EPA Docket No. EPA-R06-OAR-2010-0846

This letter responds to the Environmental Protection Agency's (EPA's) Federal Implementation Plan for Interstate Transport of Pollution Affecting Visibility and Best Available Retrofit Technology (BART) Determination as proposed in the Federal Register on January 5, 2011.

NPS Comments on the Best Available Retrofit Technology (BART) Determination by EPA for Public Service Company of New Mexico's San Juan Generating Station, Units 1-4 March 31, 2011

EPA's Region 8 Office has compiled a graphic presentation of SCR capital costs—please see Appendix B for "SCR References"

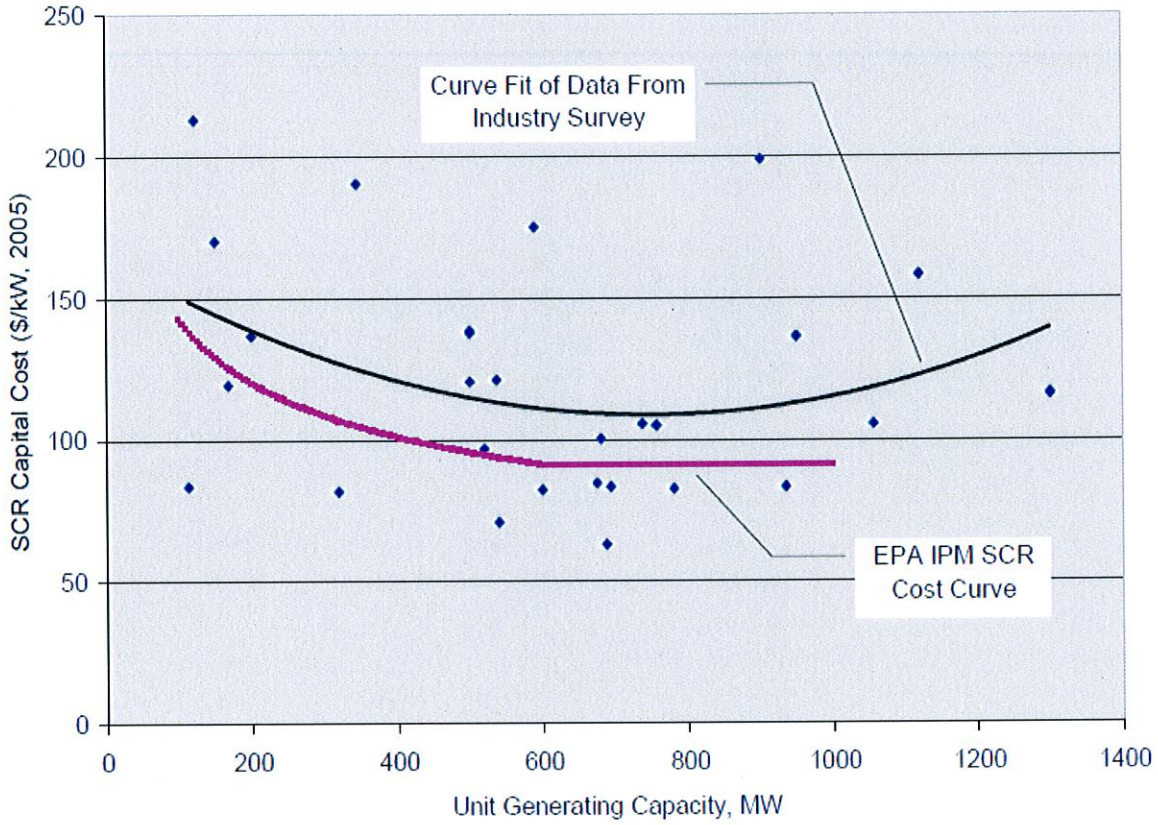
The EPA data confirm that SCR capital costs typically range from $73 – $243/kW. In comparison, PNM's cost estimates for SJGS appear to be overestimated.
